RESOLUTION NO. R- 2314

A RESOLUTION OF THE CITY COUNCIL OF THE CITY OF KIRKLAND APPROVING THE PRELIMINARY PLAT OF "FINKBEINER ADDITION TO KIRKLAND", AS APPLIED FOR BY STAFFORD HANSELL COMPANY, BEING DEPARTMENT OF COMMUNITY DEVELOPMENT FILE NO. SUB-75-26(H), AND SETTING FORTH CONDITIONS TO WHICH SUCH PRELIMINARY PLAT SHALL BE SUBJECT.

DEPARTMENT OF COMMUNITY DEVELOPMENT
ADVISORY REPORT
 FINDINGS, CONCLUSIONS AND RECOMMENDATIONS

FILE NUMBER SUB-75-26 (H)
 APPLICANT Stafford Hansell Company
 PROPERTY LOCATION Betw NE 60th St & 58th St & BNRR & Approx 106th Ave. NE
 Application for Preliminary Subdivision (Finkbeiner Add. to Kirkland) to divide one parcel into 21 lots.
 SUBJECT _____
 HEARING/MEETING DATE _____
 BEFORE _____

EXHIBIT "A"
R-2311

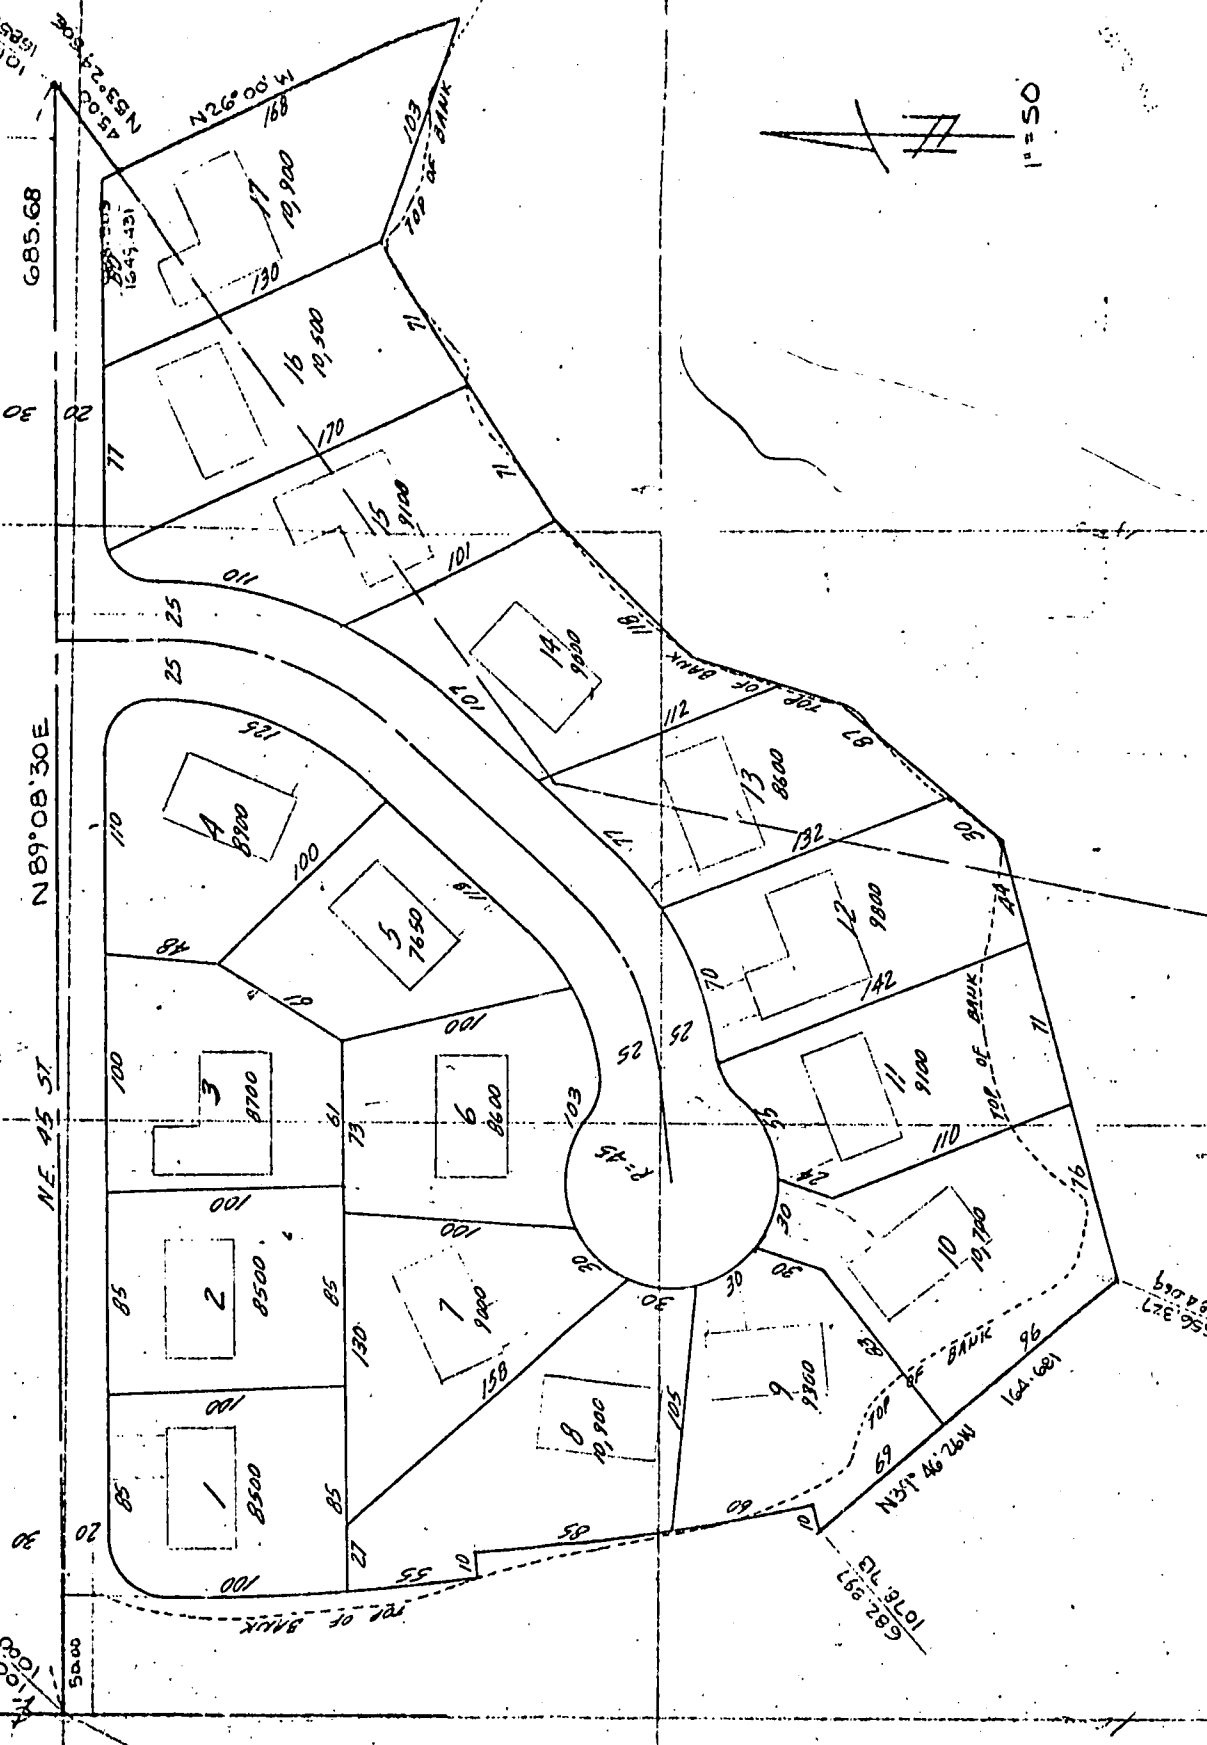
6. Dept. of Public Services: "The above plat is within LID #115 and the proposed plat can be segregated so far as sewer assessments are concerned. A 6" water main should be run north-south through the plat to connect to east-west 6" mains on N.E. 58th also N.E. 60th. The frontage on N.E. 58th and N.E. 60th should be improved to a 32 foot curb to curb one-half street."

7. Fire Services - "N.E. 58th St. needs to be widened. There is an existing 6" main along N.E. 58th. There appear to be sufficient hydrants already installed, however, would strongly recommend a fire hydrant in the cul-de-sac if a 6" main goes through center of plat."

8. Building Department - "Cul-de-sac should be labeled 105th Ave. N.E. as this street is on the City grid."
9. Park Department - "The Park Department recommends that the Finkbeiner plat be required to pay the 10% assessment to the fee in lieu of fund. Further, that at such time as Tract A is subdivided (either short or formal) the assessment for Tract A shall then be paid."

17. The applicant has submitted a tree cutting plan. (See Exhibit "A")
18. The applicant should be required to provide calculations and design drawings which will minimize soil erosion potential.

Based upon the foregoing Findings and Conclusions we hereby recommend approval of this preliminary plat of "Finkbeiner Addition to Kirkland" identified in Exhibit "A" subject to the following conditions:

1. Prior to the installation of any required utilities, grading, clearing, or development within the preliminary plat, however excluding a building permit for Tract "A", the applicant shall submit engineering calculations, drawings, drainage design for the entire plat, and design proposed storm water retention system and erosion measures to be taken during construction and after development so that the velocity and quantity of runoff from the site does not exceed the existing runoff from a 10-year, one-hour storm. This shall include a drainage easement along the undeveloped portion of N.E. 58th Street. Natural drainage controls will be preferred over structural methods within the plat.

2. Removal of vegetation shall be limited to those trees within the right-of-way, utility easements, and homestead clearing with individual trees within the proposed lots to be identified and tagged, and approved by the Department of Community Development prior to tree removal within these lots. Those trees within the landscaping island shall be retained.

- b. Grade the undeveloped portion of N.E. 58th St. to the approval of the Public Service Department.
 - c. 105th Ave. N.E. shall be dedicated and improved to minimum City standards with a sidewalk on the west side of the street. Beauty bark shall not be used in the landscaping island.

- d. The applicant shall install a 6" water main and connect said main to the existing 6" mains on N.E. 60th St. and N.E. 58th St. Further, a fire hydrant shall be installed within the cul-de-sac.

- g. Provide a 10 foot pedestrian easement between Lots 12 and 15; and 3 and 4, and improve this easement with a 5 foot wide concrete path, fencing either side of the easements, to include a baffle system, and landscaping within the easement as indicated in Exhibit F.
